**Eugene School District 4J
ROOSEVELT MIDDLE SCHOOL**
680 East 24th Avenue
Eugene, OR 97405
CIP No. 410.566.001

ADDENDUM NO. 3

This Addendum forms a part of the Contract Documents and modifies the original Bidding Documents dated February 18, 2015 as noted below. Acknowledge receipt of this Addendum in the space provided on the Bid Form. Failure to do so may subject the Bidder to disqualification.

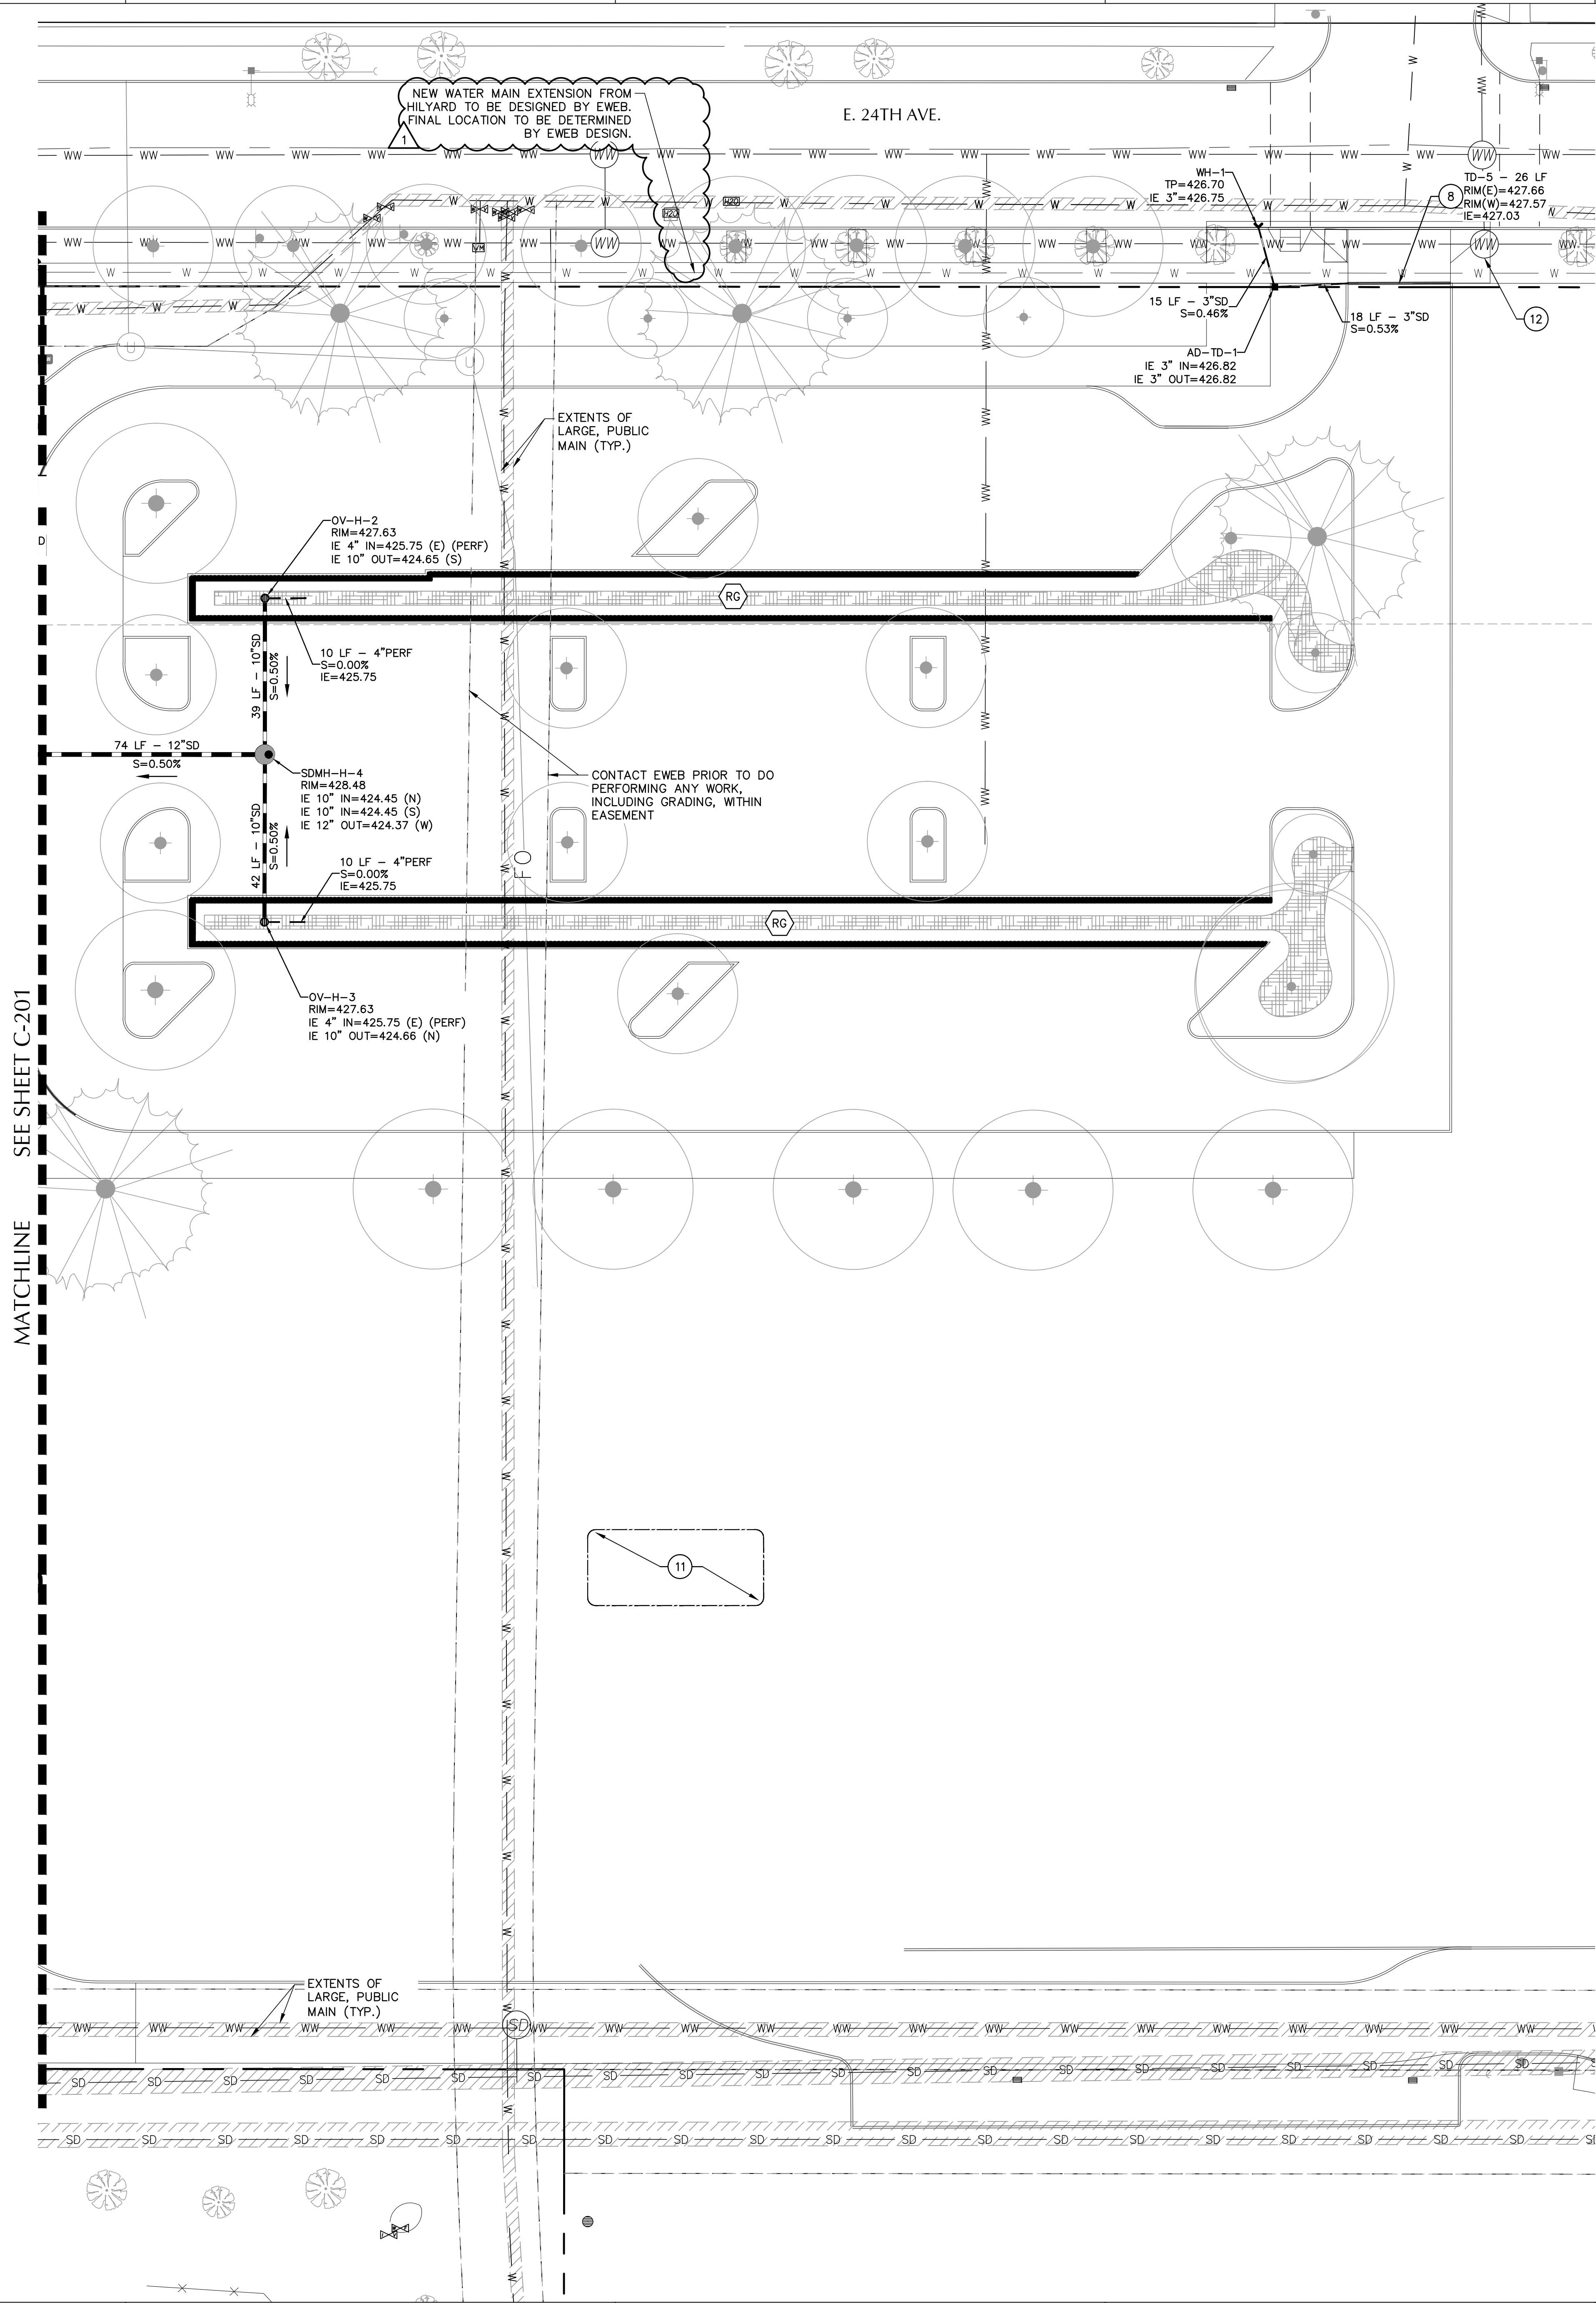
- A. Replace Sheet with attached new Sheet C-201. Clarification: Modifications to utilities.

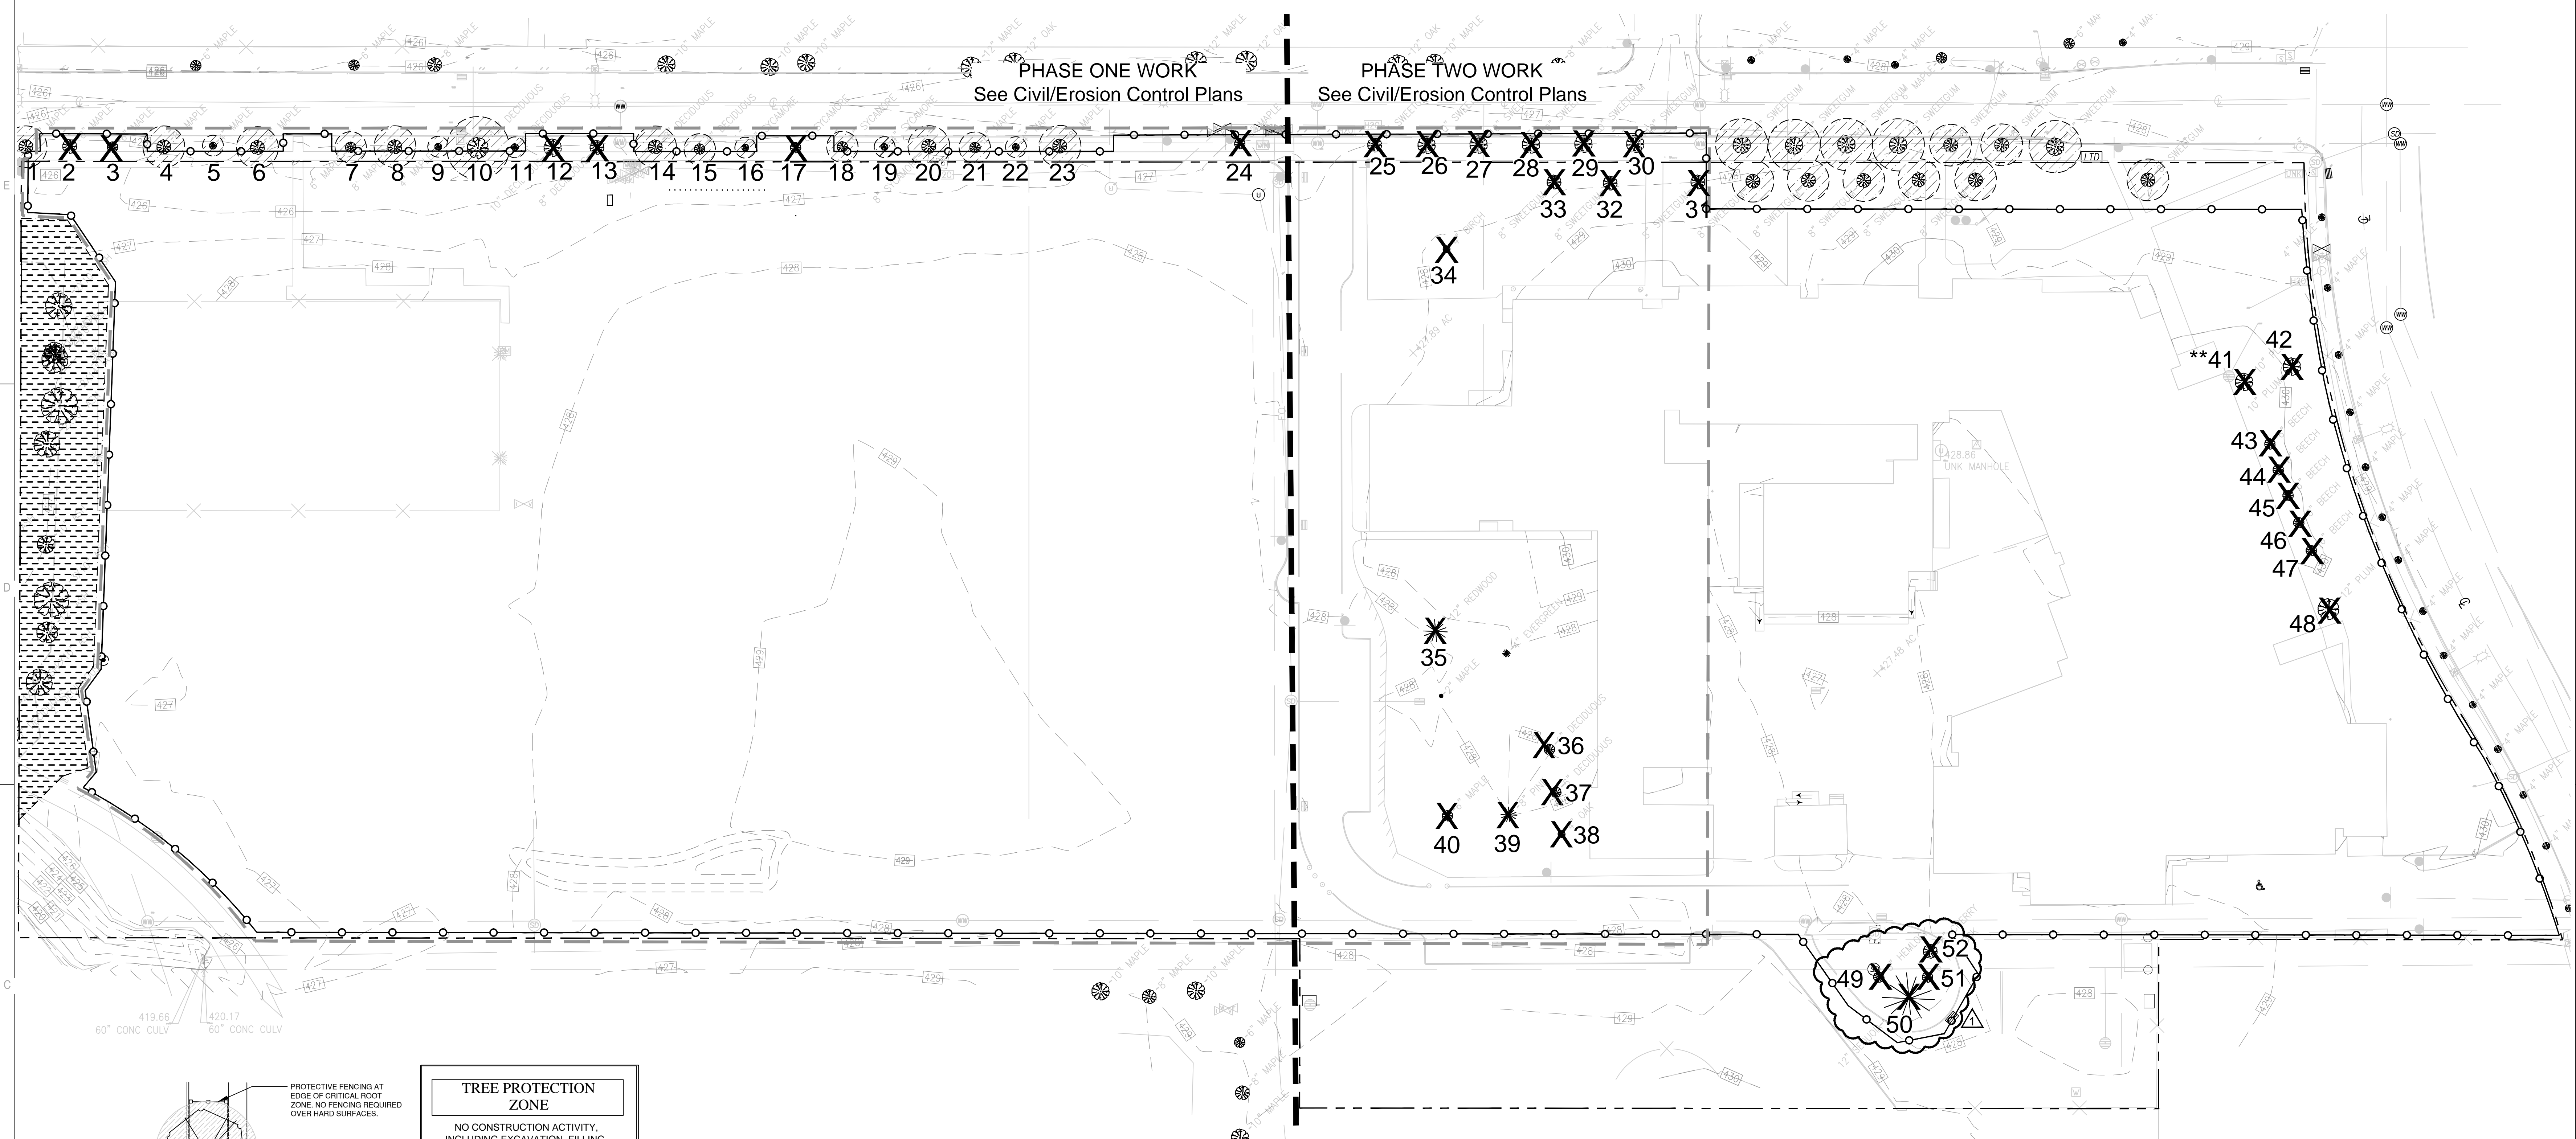
- A. Replace Sheet with attached new Sheet L-100.1. Clarification: Removed four existing trees at island south of existing RMS school for utility work improvements. See Electrical and Civil Sheets.

TREE PROTECTION AND REMOVAL PLAN

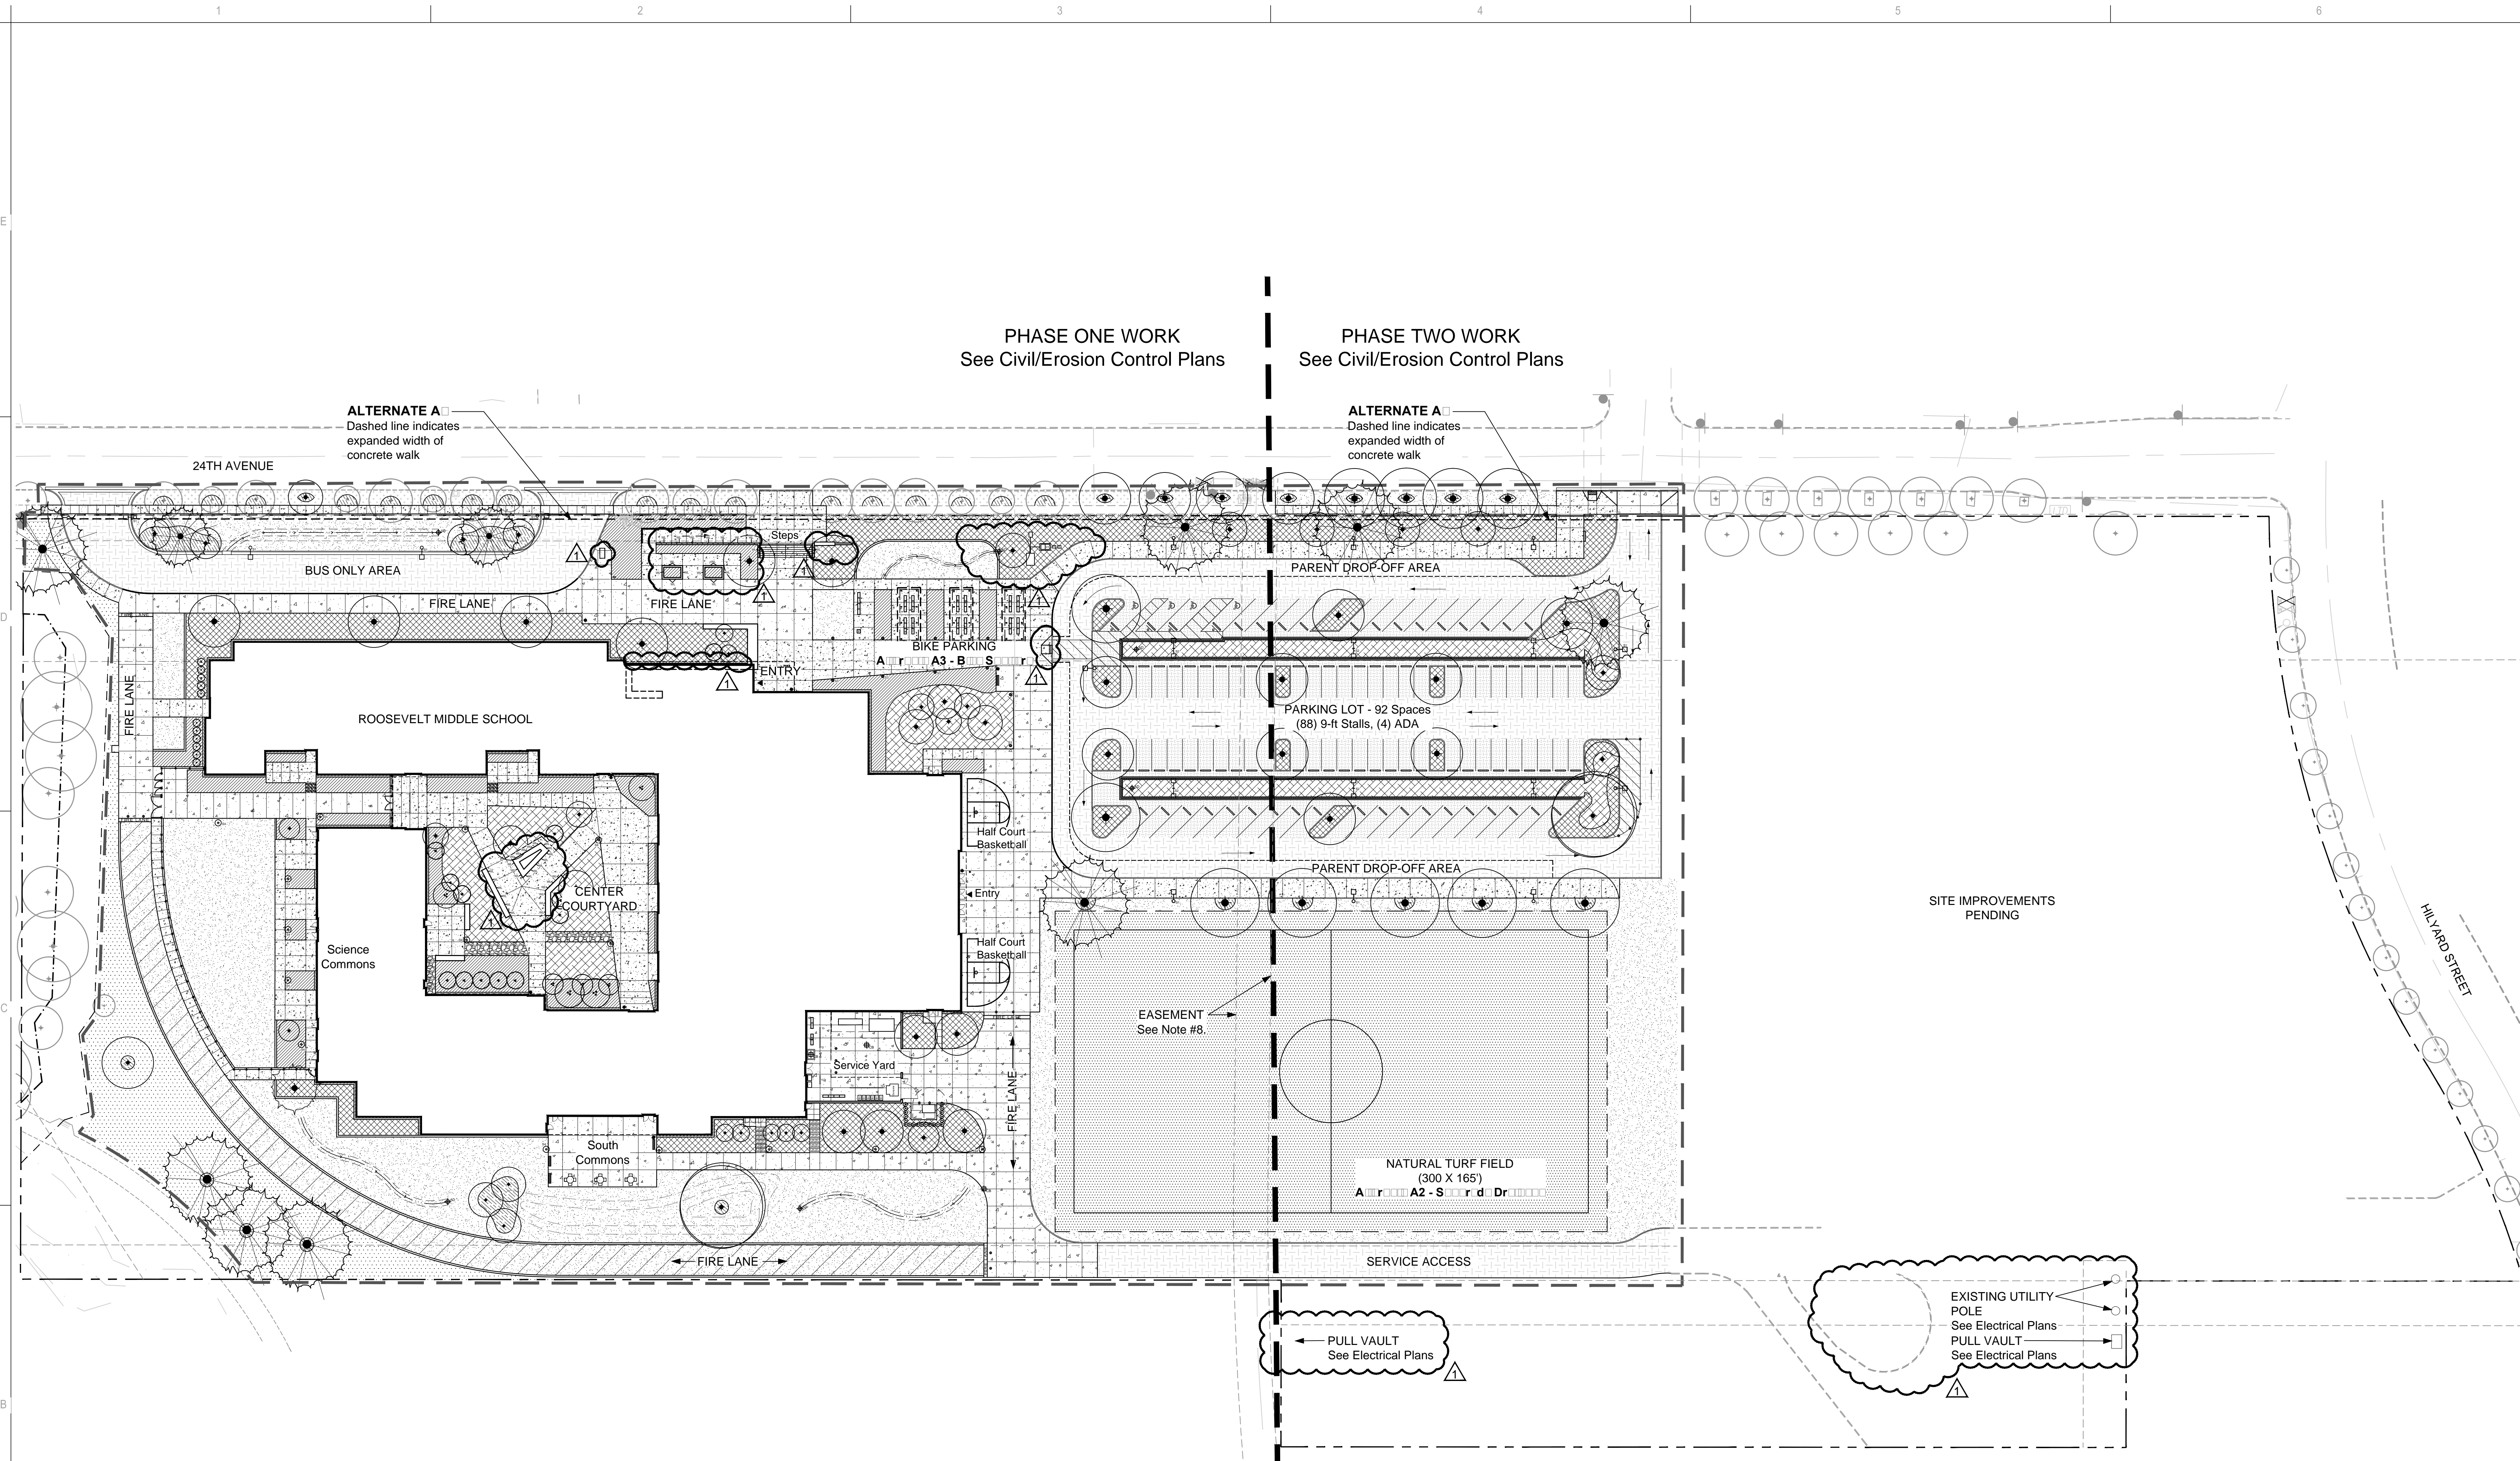
- A. Replace Sheet with attached new Sheet L-100.2. Clarification: Removed four existing trees, (#49-#52) at island south of existing RMS school for utility work improvements. See Electrical and Civil Sheets. Added removal of existing trees, #49-#52, to tree protection and removal schedule.
